Groundwater Transfer Review Summary Form

Transfer/PA # T- 13597 (temp)

Application: T-13597 (temp)

Applicant Name: Leon Kuenzi, Roger Kuenzi

Theis Drawdown and Recovery at r = 750 ft From Pumping Well

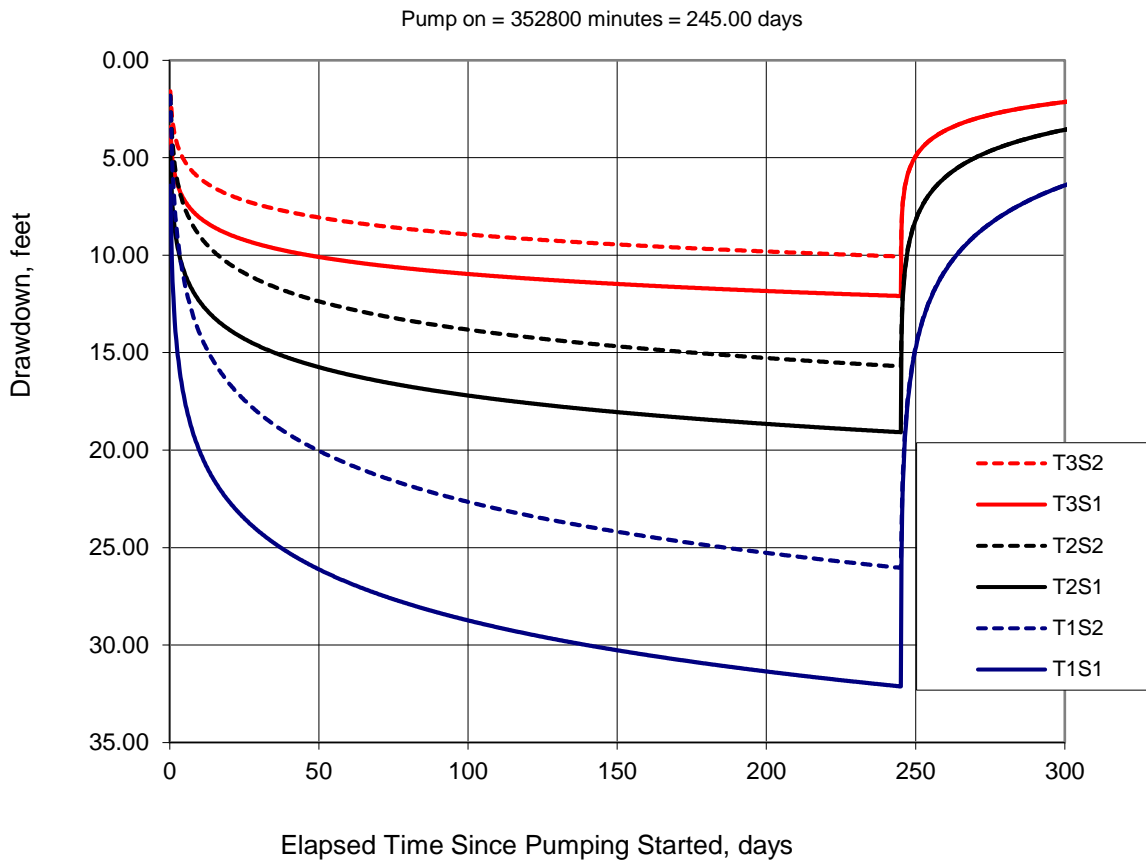
Yes No If yes, explain: Because the proposed To-POA (MARI 4399) has overlapping water rights, the combined pumping under all applicable rights, authorized and proposed, must be considered. The combined pumping rate would total 1.1 cfs (~494 gpm). A Theis (1935) drawdown analysis was used to assess the amount of increased interference with MARI 4454 due to the proposed transfer (see attached Theis Drawdown Analysis). Results of the analysis indicate that the proposed transfer is unlikely to deprive MARI 4454 or similarly-located wells of water to which they are legally entitled.

Pumping Rate (Q) = 1.1 cfs \approx 494 gpm [Combined Maximum Rate for MARI 4399]
 T1 = 2000 ft²/day | T2 = 3600 ft²/day | T3 = 6000 ft²/day [OWRD Pumping Test Data]
 S1 = 0.0004 | S2 = 0.002 [Domenico and Mifflin, 1965; Freeze & Cherry, 1979; Halford and Kuniatsky, 2002; McFarland and Morgan, 1996]
